Submissions Report

*SSD-87486461
20-22 Atchison Street, St
Leonards*

Director Stephen White
Associate Director Eliza Scobie
Consultant Rachel Motherway
Project Code P0060848
Report Number FINAL_MARCH 2026

Figure 4 Ground Floor Café Activation Plan

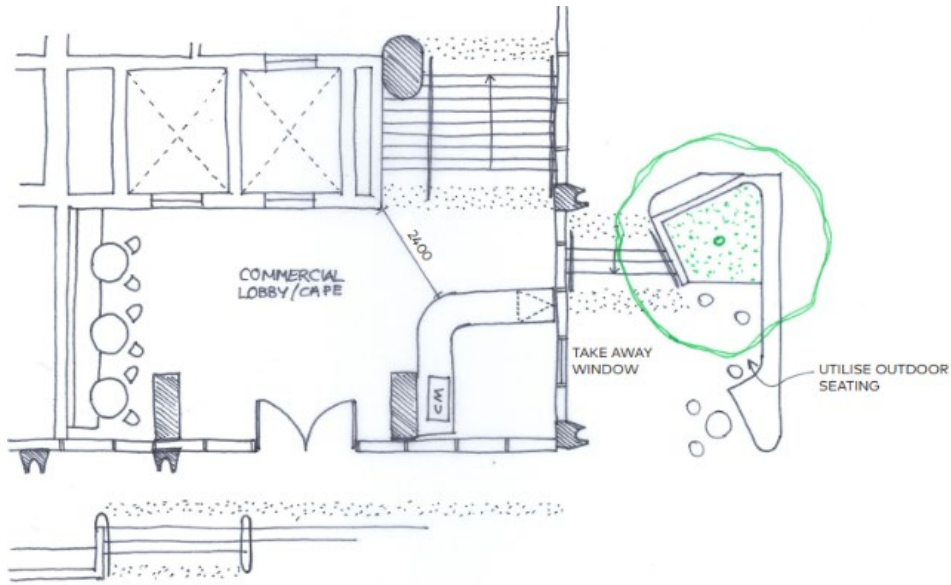
2. Urban design	<i>a) Consider alternative design options or removal of the fixed glass louvres to reduce the bulk and scale of the development and ensure compliance with the FSR control.</i>	<p>Alternative design identified above have been considered to remove the fixed glass louvres on specific levels of the development in order to reduce perceived bulk and scale. The proposed alternative design options are illustrated in Figure 7 and Figure 8.</p> <p>The proposed louvres are glass and therefore do not contribute to bulk, as they are integrated into the tower</p>	Appendix D Appendix K Appendix L

<p><i>c) Consider improved street activation and/or landscaping of the through -site link along the western boundary of the site to screen the inactive facade.</i></p>	<p>A proposed public art zone has been proposed along the western boundary of the site. This public art zone is to be implemented by the applicant post-approval during the detailed design development stages. This provides an opportunity to activate the blank edge of the podium facing the existing through-site link. This is considered a more feasible and long-term design solution to landscaped walls, as feasible testing on a successful Greenwall (by a Landscape Architect) identified that the western façade is subject to a significantly unfavourable microclimate due to:</p> <ul style="list-style-type: none"> ▪ Severe lack of natural light due to overshadowing from adjacent built form ▪ Persistent wind exposure and downdraft effects, typical within narrow through-site links and high-rise urban environments ▪ Temperature fluctuations that create plant stress and reduced survivability 	Appendix I Appendix L

Key Issue	Description	Response	Refer to
Other Issues	<p>a) <i>The proposal involves a significant variation to the non-residential FSR development standard and is a key concern raised by Council. Consider increasing the provision of non-residential FSR to more closely align with the standard.</i></p>	<p>The Economic Analysis prepared by Urbis (September 2025) identifies:</p> <p><i>The commercial office market in St Leonards/Crows Nest is facing significant challenges, with vacancy-rates anticipated to remain above 25% over the next ten years.</i></p> <p><i>Considering the existing stock, planned additions and withdrawals of office floor stock in the area, the market would support a limited amount of commercial floorspace in the podium of the proposed development, of approximately 1,500 sqm in 2028, when the development is due for completion</i></p> <p><i>As of January 2025, the vacancy in the Study Area was 108,927 sq.m (30.5%), the highest for any commercial office market in Sydney, a worrying prospect for owners of buildings located in the Crows Nest/St Leonards office market.</i></p> <p><i>In addition to this, weak absorption levels in Crows Nest/St Leonards continue, as the market has been subdued by competition from newer stock in other office markets and the better located North Sydney and Sydney CBD markets.</i></p> <p>The development proposes 1,938sqm commercial floor space. A further increase in commercial floor space would not be supported by the market as the current and forecast demand does not justify additional supply. Introducing more office floorspace in this context risks long-term vacancy and underperforming assets. Prioritising non-residential uses that support a diverse, active and resilient centre better aligns with contemporary planning objectives and the current housing crisis.</p> <p>The Submissions Report therefore does not seek to increase the non-residential FSR however there is an increase in the diversity of the commercial floor space provided. As outlined previously, a café tenancy is proposed on the ground</p>	Appendix K

- Widening of vehicle crossing to lower ground floor vehicle entrance to accommodate Salt3 updated swept paths, refer to Appendix J (Waste Management Plan) for further details.
- Activation of the Commercial Lobby to the ground floor through the insertion of a café that trades both internally and through a takeaway window adjacent to the Mitchell St Landscaped setback.
 - Refer to Figure 4 for the Ground Floor Activation Plan details.
- Nomination of public art zone to western wall of podium.

Figure 7 Balcony Design

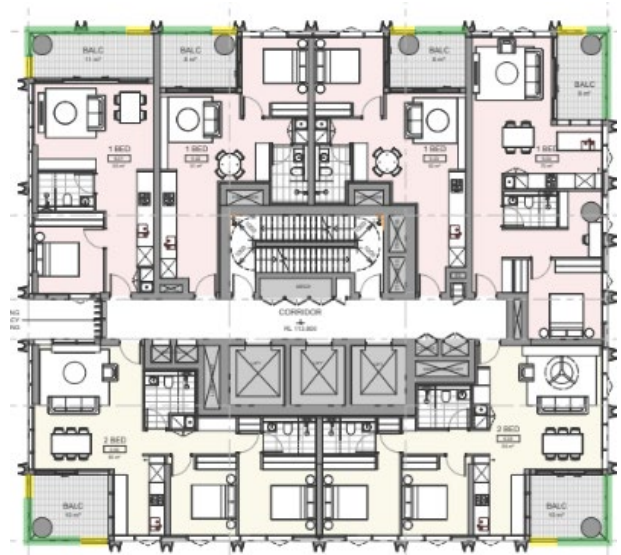
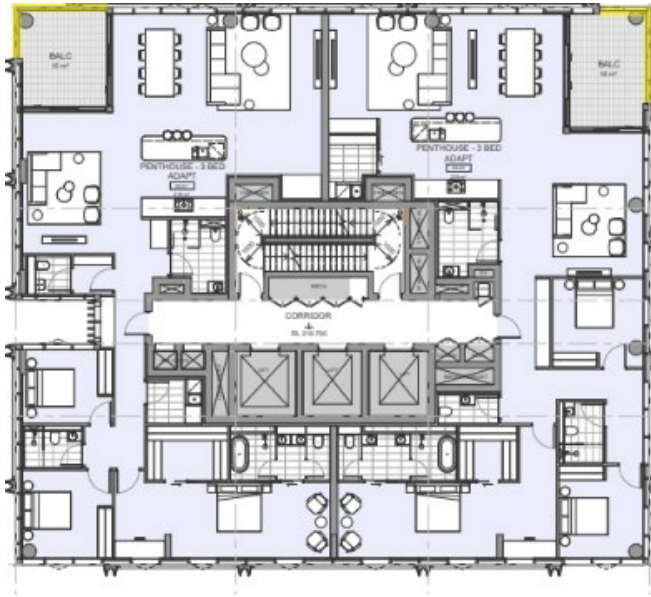
Key Issue	Description	Response	Refer to
1. Gross Floor Area	<i>The fixed glass louvres included throughout the residential levels of the building allow for fully enclosed balconies and are therefore considered residential gross floor area (GFA) in accordance with the North Sydney Local Environmental Plan 2013. The balcony balustrades on Levels 2 and 3 also exceed 1.4 metres in height, potentially contributing to additional GFA. The total GFA of the development must be confirmed taking into account these matters. Any exceedance of the maximum floor space ratio (FSR) control for the site must be addressed in a clause 4.6 variation request.</i>	<p>To minimise the amount of fully enclosed balconies, the following changes are proposed:</p> <ul style="list-style-type: none"> ▪ Levels 2 and 3: 1100mm glass balustrade. ▪ Levels 6-14: contain primarily a 1400mm glass balustrade, with fixed louvres in certain positions. ▪ Levels 15-29: majority contain fixed louvres; however a 1400 glass balustrade is provided in certain positions. ▪ Levels 30-39: majority contain fixed louvres, however some on the southwest corner contain operable louvres. <p>The fixed louvres proposed are not fully enclosed with 30% openings. Therefore, the GFA on these balconies has not been incorporated into the total GFA calculation.</p> <p>As a result, the total GFA proposed is 18,961sqm with an FSR of 13.82:1.</p>	Appendix D Appendix K Appendix L

Figure 7 and Figure 8, (read with the legend at Figure 6) illustrate the updated balcony design across the development. The proposal introduces a modified approach with different balustrades and louvres proposed on different level sections, responding to the wind exposure identified in Appendix D (Wind Impact Assessment) . These changes are justified further in Section 4.1.

- **Podium typical Plan Level 2&3:** solid balustrade
- **Tower typical plan level 6-14:** glass balustrade and glass balustrade with fixed louvres above
- **Tower typical plan level 15-29:** glass balustrade and glass balustrade with fixed louvres above
 - Note levels 15-29 contain more fixed louvres than levels 6-14 in response to the wind report.
- **Tower typical plan level 30-38:** glass balustrade, glass balustrade with fixed louvres above and glass balustrade with operable louvres above
 - The south-western is entirely enclosed in response to the wind report.
- **Tower Plan Level 39:** glass balustrade with fixed louvres above
 - This level contains entirely enclosed balconies which results

It is important to note that fully enclosed balconies on levels 30-39 fully are included in the developments GFA calculations.
